Tesla, Inc.
Service Bulletin

Rework Spoiler Outer Panel

SB-25-11-007

On certain Model Y vehicles built at Giga Berlin, a gap between the liftgate and the spoiler outer panel may produce a whistling sound if the vehicle is driven at high speed.

Figure 1 – RH shown, LH similar.

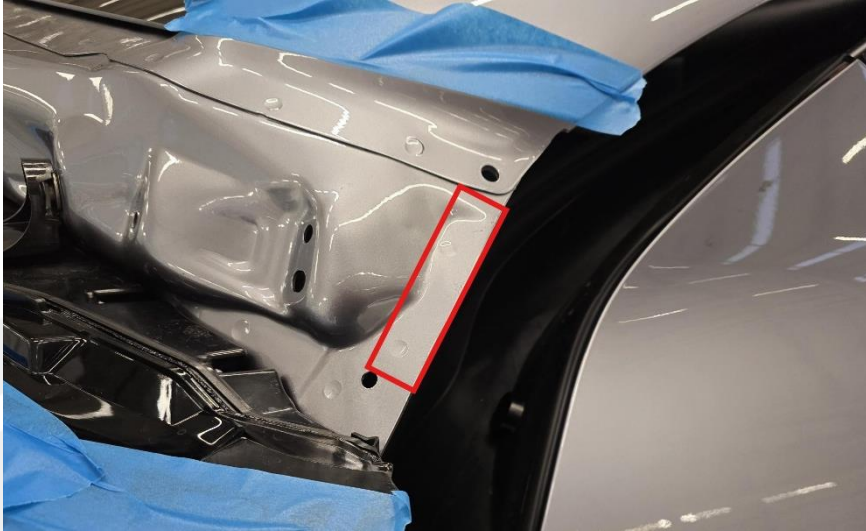
1. Remove the spoiler outer panel (refer to Service Manual procedure [1133050502](#)).
2. Clean the LH and RH edges of the liftgate with IPA wipes, and then allow 1 minute to dry (Figure 1).

Figure 2 – RH shown, LH similar.

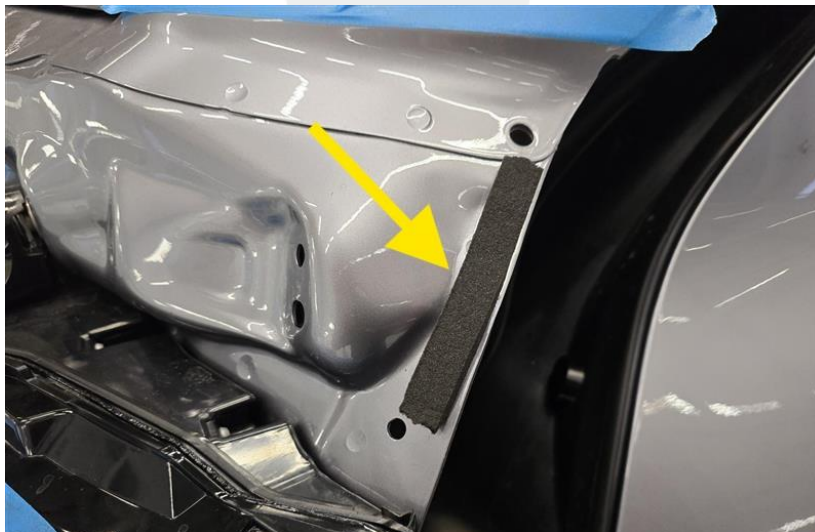
3. Prepare two pieces of tape. Cut the tape at a length of 9,5cm (3.75in).
4. Apply the pieces of tape (x2) on the LH and RH edges of the liftgate, leaving a gap of 5mm from the edge of the liftgate (Figure 2).
